Model	DF61 (PYRENEES)	Volt/Hz	Date of Modification	Serial Number
Modified Article	Parts Catalog			
Reason for Modification	Parts Catalog Correction

Model	DF61	Volt/Hz	Date of Modification	Serial Number
Modified Article	Original Sensor	No serial number cut-in information.		
Reason for Modification	To prevent the original sensor feeler from being caught

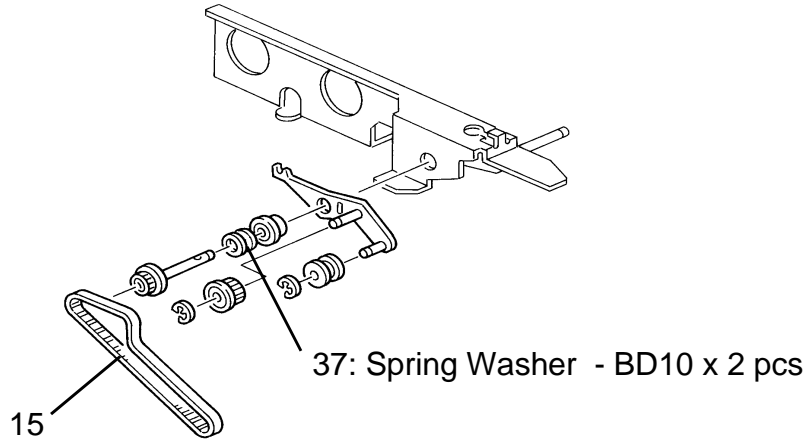
Please correct your parts catalog as follows:

Incorrect P/N	Incorrect Description	Correct P/N	Correct Description	Parts Catalog	
				Index No.	Page
A5482171	Paper Feed Shaft	A5481271	Separation Roller	9	5

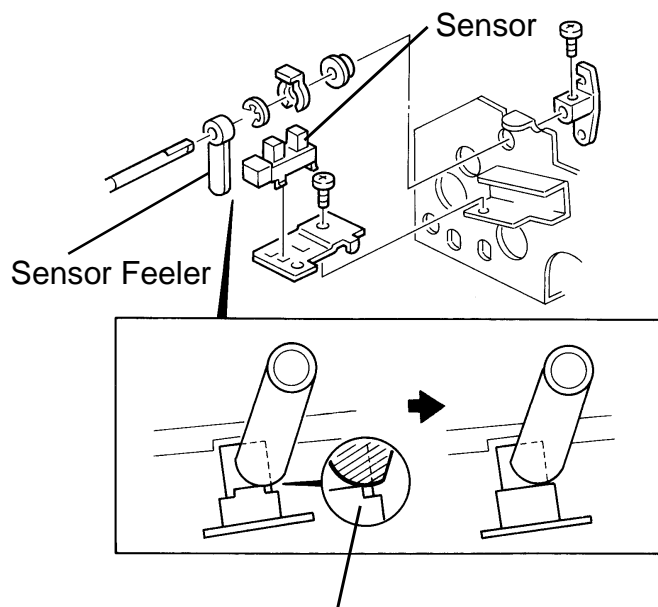
The shape of the photointerruptor has been changed as shown below to prevent the original sensor feeler from being caught by the notch at the edge of the sensor.

Old P/N	New P/N	Description	Q'ty Used	Inter-changeability	Parts Catalog	
					Index No.	Page
AW02 0021	AW02 0075	Photointerruptor	1 → 1	X/O	9	7

The feeler may be caught by the notch at the edge of the sensor.

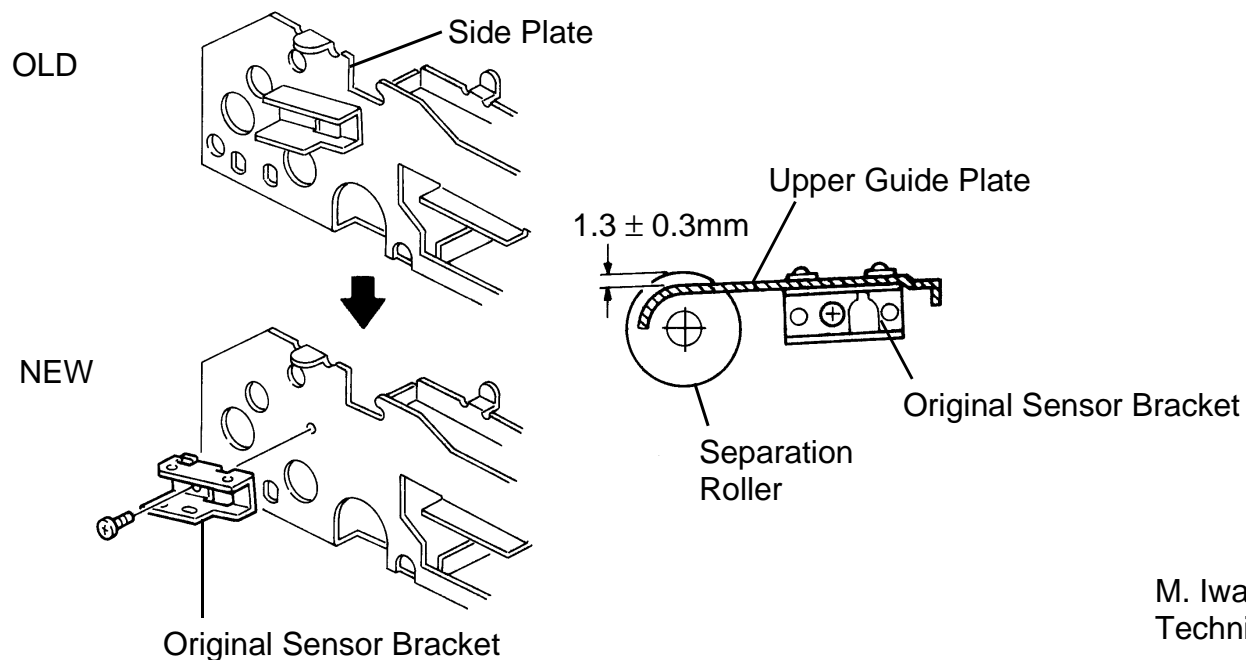
The original sensor bracket has been separated from the side plate as shown below.

Old P/N	New P/N	Description	Q'ty Used	Inter-changeability	Parts Catalog	
					Index No.	Page
	A548 1127	Original Sensor Bracket	0 → 1

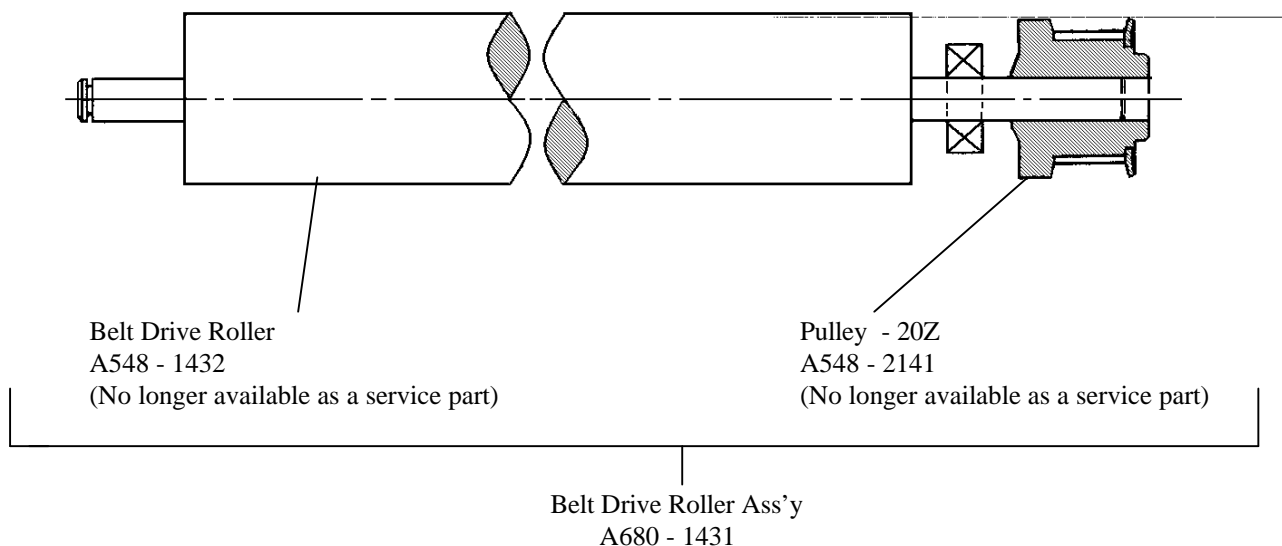
Old part number	New part number	Description	Qty	Int	Page	Index	Note
A548-1432		Belt Drive Roller	1		9	1	
A548-2141		Timing Pulley - 20Z	1		9	13	
	A680-1431	Belt Drive Roller Ass'y	1	X/O	9	1

The individual part numbers for the belt drive roller and the timing pulley - 20Z are listed in the parts catalog, but the roller shaft is actually press-fit into the pulley on the production line. The pulley - 20Z cannot be installed on the roller shaft in the field.

A part number has been assigned for the belt drive roller assembly instead of for the belt drive roller and the timing pulley.

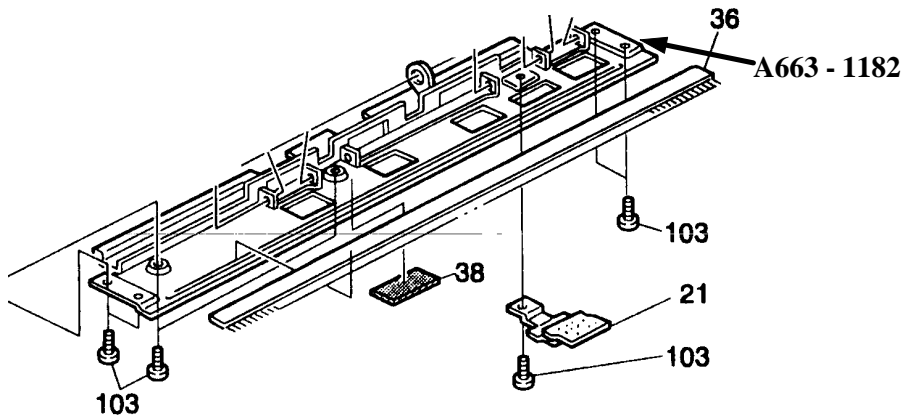
Old part number	New part number	Description	Qty	Int	Page	Index	Note
	A663 - 1182	Base Bracket - Original Feed	1	—	5	40

A part number has been assigned for the Base Bracket - Original Feed.

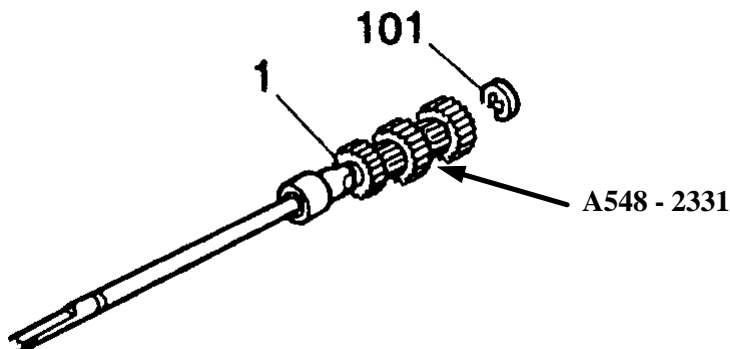
The part number #A548 - 2331 listed on page 5 (Index 1) is for the entire assembly unit. The description of the Index 1 has been corrected as follows.

Incorrect Description	Correct Description	Page	Index
Gear - 23Z	Drive Gear Ass'y	5	1

Note: A part number has not been assigned for the individual part.

Page 12

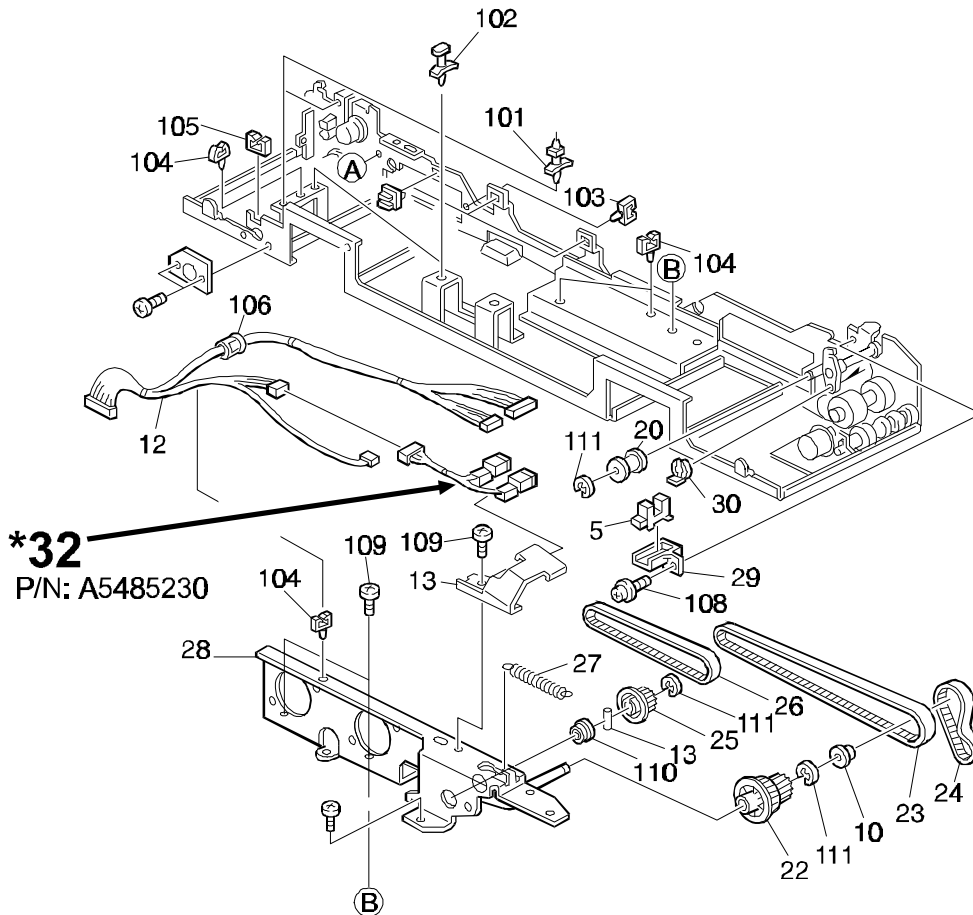
The index number was missing inside the following illustration.
Please add the following number as shown below.

New part number	Description	Qty	Page	Index
A548 5230	Indicator Harness	1	12	32

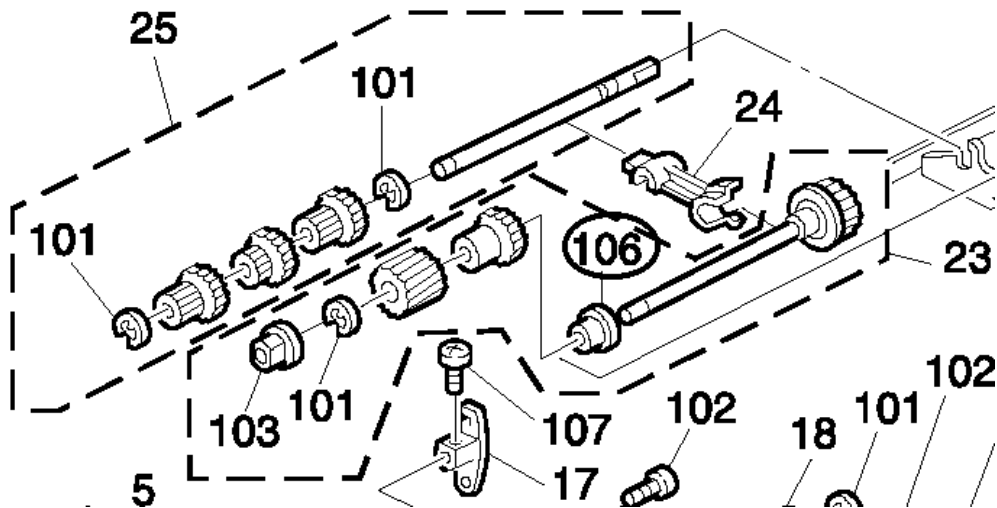
Old part number	New part number	Description	Qty	Int	Page	Index	Note
07403906	A2323564	Ball Bearing – 6x15x5		O/O	7	106

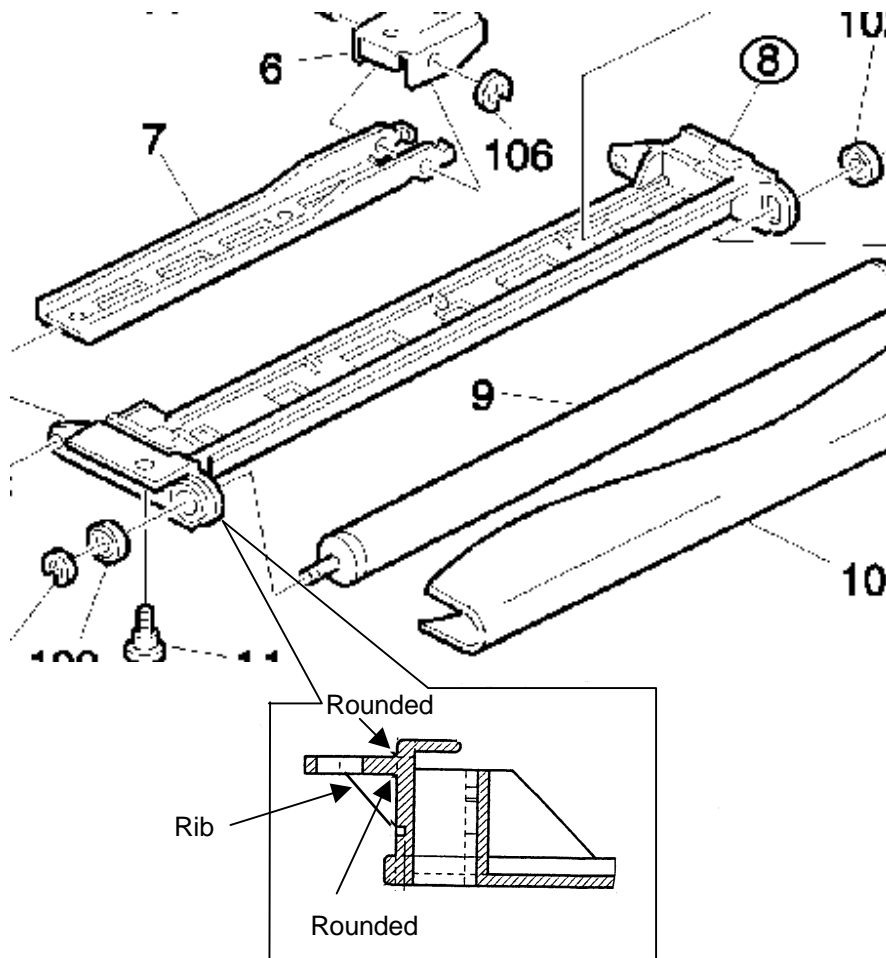
Old part number	New part number	Description	Qty	Int	Page	Index	Note
A5481422	A6631422	Transport Stay	1 - 1	X/O	9	8

The part of the transport stay which comes in contact with the surface of the transfer belt has been changed from a smooth surface to a rough one to prevent noise.

The part of the stay, shown in the illustration, has been rounded and a rib has been added to prevent breakage due to stress.

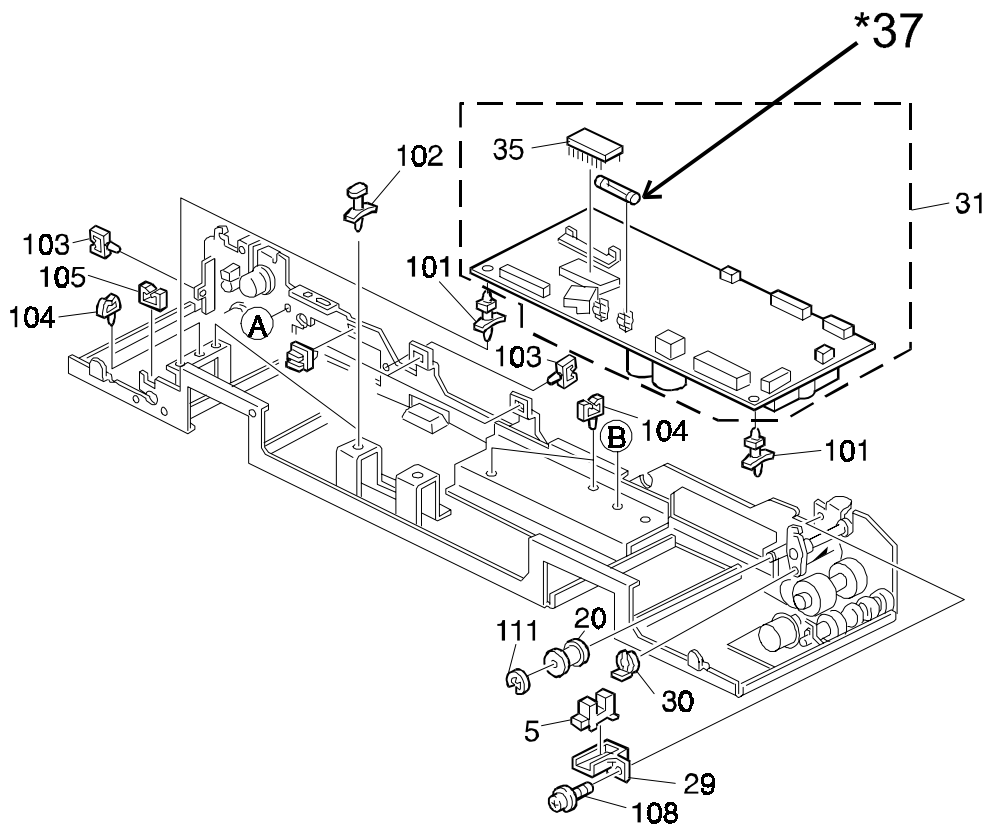
Please add the following part to your parts catalog.

New part number	Description	Qty	Page	Index
1107 0750	Fuse - 3.15A 250V	1	13	37

Page 13

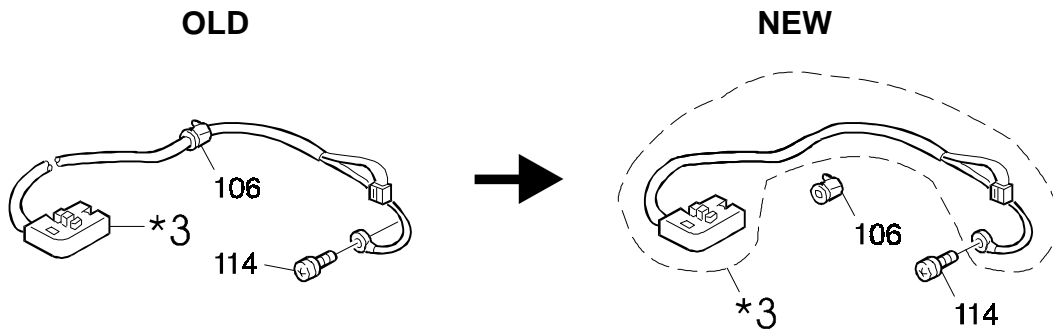
Please correct your parts catalog as follows:

Old part number	New part number	Description	Page	Index
A548 5281	A548 5280	Interface Harness	13	3

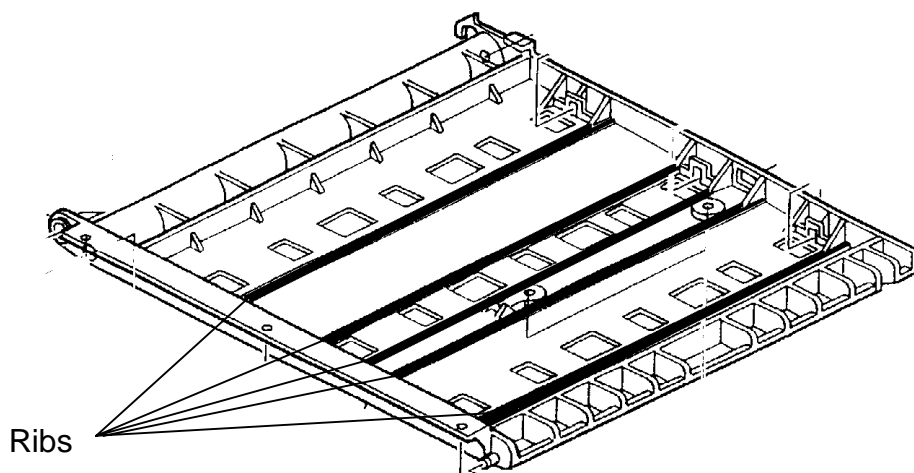
To prevent the transport base plate from being bent, the height of the five ribs on this part has been increased by 15 mm.

If the transport base plate is bent, an original jam may occur as a result of the transport belt stopping.

Old part number	New part number	Description	Qty	Int	Page	Index	Note
A5481412	A6631412	Transport Base Plate	1-1	X/O	9	4
